CMD: 19-M7

Commission Request for Information

**Darlington Nuclear  
Generating Station:  
CNSC Staff Update on  
Alpha Contamination  
Event – Action from  
November 8, 2018  
Commission Meeting**

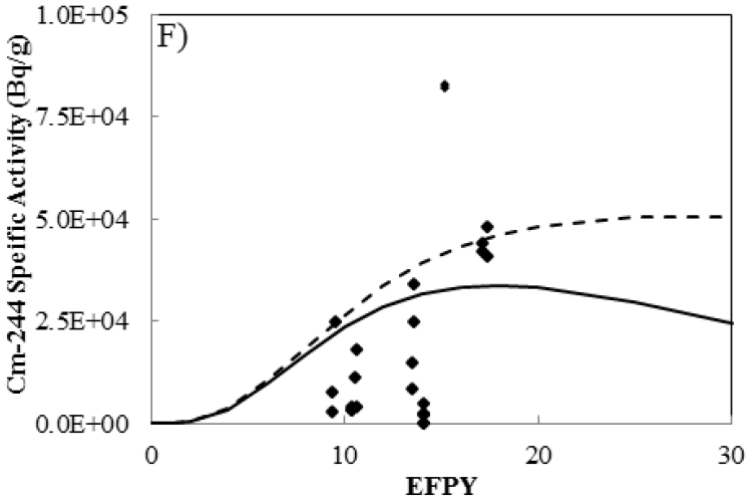
vi.	Does <b>OPG</b> have reliable measurements of <i>the inventory of Cm-244</i> in its pressure tube wastes?	<p>OPG has an active waste characterization program, including pressure tube measurements and Darlington End Fitting and Liner Tube data. A partial summary of the CANDU pressure tube data analysis was published (3rd Canadian Conference on Nuclear Waste Management, Decommissioning and Environmental Restoration Ottawa Marriott Hotel, Ottawa, ON, Canada, September 11-14, 2016. Measurements, from several CANDU units, indicate that Cm-244 is present in significant amounts in pressure tube material).</p>	<p>While OPG has provided some amount of assurance that it has in the past and continues in the present to characterize the CANDU pressure tubes (PTs), and that these activities have included Cm-244, <b>OPG's response has not fully addressed the question.</b></p> <p>CNSC staff provide the following additional details:</p> <p>CNSC staff note that OPG's response references published literature and not an internal report. Cm-244 can be released from the fuel into the Primary Heat Transport (PHT) system when a fuel defects. The non-volatile radionuclides quickly plate out on the first</p>

Item	Question	OPG Response	CNSC Staff Assessment
		<p>OPG continues to conduct measurements to increase the extent of its waste characterization database. The included graphic shows a general distribution of Cm-244 specific activity vs Equivalent Full Power Years for various CANDU units.</p>  <p>The figure is a scatter plot labeled 'F)'. The vertical axis is labeled 'Cm-244 Specific Activity (Bq/g)' and has major tick marks at 0.0E+00, 2.5E+04, 5.0E+04, 7.5E+04, and 1.0E+05. The horizontal axis is labeled 'EFPY' and has major tick marks at 0, 10, 20, and 30. There are approximately 15 data points represented by small black diamonds. A dashed line represents a trend, starting at (0,0), rising to a peak of about 5.0E+04 Bq/g at 20 EFPY, and then slightly declining. Another solid line shows a similar trend but lower, peaking at about 3.5E+04 Bq/g. The data points are widely scattered, with one notable outlier at approximately (15, 8.5E+04).</p>	<p>cold surface they interact with, specifically in this case the pressure tubes. The quantities are very specific to the fuel defect, the length of time the defect stays in core and the size of the defect. A correlation between Effective Full Power Year (EFPY) and Cm-244 would at best be a very rough correlation and not necessarily a good fit for all CANDU plants given that fuel performance/defect rates differ among them. In these situations direct measurements are the most reliable data source - see also Item vii regarding the application of the ALARA principle.</p> <p>In their review of Enclosure 2 (while not cited in OPG’s response to this question), CNSC staff note that 10 samples were collected specifically within or adjacent to the two RWPB Hardware Stations; these samples were collected on February 20, 2018, shortly after the alpha-event (February 6, 2018). With respect to alpha-emitting nuclides analyzed for (Pu-238, Pu-239/240, Am-241, Cm-242 and Cm-243/244), Cm-243/244 is consistently the most prevalent in these 10 samples. OPG has not referenced these results in their answer to this question, despite having included them in the overall response.</p> <p>CNSC staff also note that Enclosure 1 contains considerable analysis, albeit of historical data (2010-2013), of theoretical models, and of sister stations/units, much of which speaks to the radionuclides that may be present and their anticipated relative ratios in various refurbishment work activities. OPG has not referenced this document (or its results) in their answer to this question, despite having included it in the overall response.</p> <p>During the conduct of the reactive inspection (March 2018), CNSC staff raised an enforcement action (DRPD-2018-008-AN02) requesting OPG to produce a radionuclide characterization specific to this new RWPB.</p> <p>During the conduct of the reactive inspection, CNSC staff found that OPG utilized historical plant data in the refurbishment planning of Darlington Unit 2 as well as past</p>

Item	Question	OPG Response	CNSC Staff Assessment
			<p>analyses to develop its work plans. Conduct of work has relied on use of field instruments to verify safe work conditions. OPG has not implemented a planned/proactive collection of smears to validate the work planning assumptions, or to develop new baseline models in support of Darlington's refurbishment practices.</p> <p>While this matter is not an immediate health and safety concern, and given that CNSC had opened a related enforcement action, <b>CNSC staff recommend that this item can be closed.</b></p> <p>CNSC staff will continue to apply regulatory oversight to OPG's characterization of radiological work to ensure hazards are being identified and appropriate protective measures are being implemented. In addition, CNSC expectations in this regard have been strongly communicated to all licensees and will be enforced for all subsequent refurbishment projects or similar activities.</p>
